SUBJECT: Dawson Trails Filing 2, Amendment 2 (RE2025-054)
Town of Castle Rock Project (PL25-0004)

Douglas County Addressing has completed review of the Dawson Trails Filing 2, Amendment 2 plat and has the following comments:

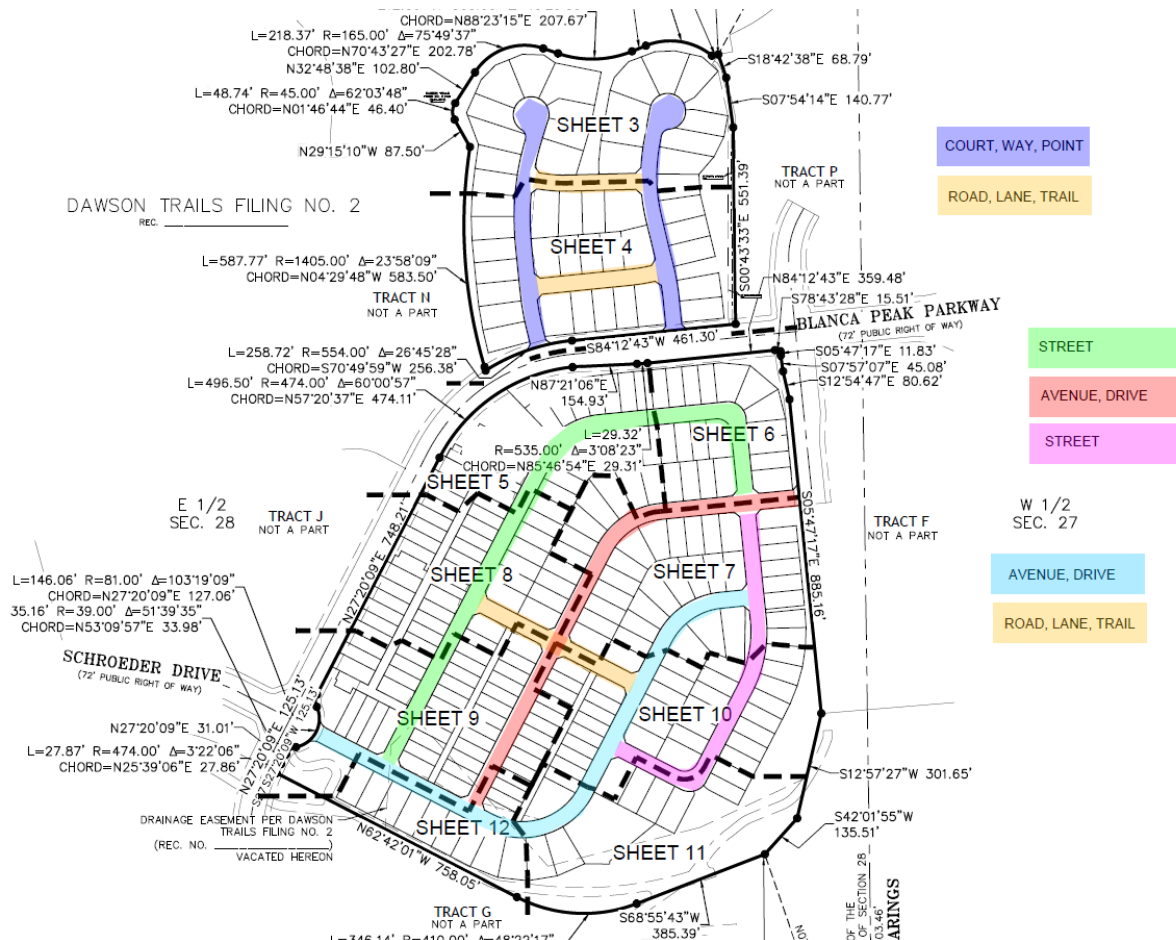
- **DUQUESNE STREET – DENIED.** This street name already exists in the County and in the 911 dispatch area. Revise the suffix to COURT, WAY, or POINT.

- **ALLEGHENY STREET –** Revise spelling. **ALLEGHENY** may be approved. Revise the suffix to COURT, WAY, or POINT.
- **JULIET STREET – APPROVED.** Revise the suffix to ROAD, LANE, or TRAIL.

- **MONTAGUE STREET – APPROVED.** Revise the suffix to ROAD, LANE, or TRAIL.
- **ANDRETTI STREET – APPROVED** with revisions. The street name change from ANDRETTI to UNSER may not occur at the 90-degree corner. ANDRETTI should continue to the intersection of LANGSAM. See the image on the following page for detail.

- **UNSER STREET – APPROVED** with revisions. The street name change from ANDRETTI to UNSER may not occur at the 90-degree corner. There are houses adjacent to one another at this corner and they should not be addressed on different streets. The change from ANDRETTI to UNSER should occur at the intersection of LANGSAM. Additionally, the change from UNSER to PRUDHOMME requires revision. UNSER should continue to the intersection of KNIEVEL. See the image on the following page for detail.

- **LANGSAM STREET – APPROVED.** Revise the suffix to AVENUE or DRIVE.
- **KNIEVEL STREET – APPROVED.** Revise the suffix to AVENUE or DRIVE.
- **GARLITS STREET – APPROVED.** Revise the suffix to ROAD, LANE, or TRAIL.

- **PRUDHOMME STREET –** Remove this street name. UNSER should continue to the intersection of KNIEVEL. See the image on the following page for detail.

Each alignment requiring a street name is highlighted in the image below. Appropriate suffixes are also shown.
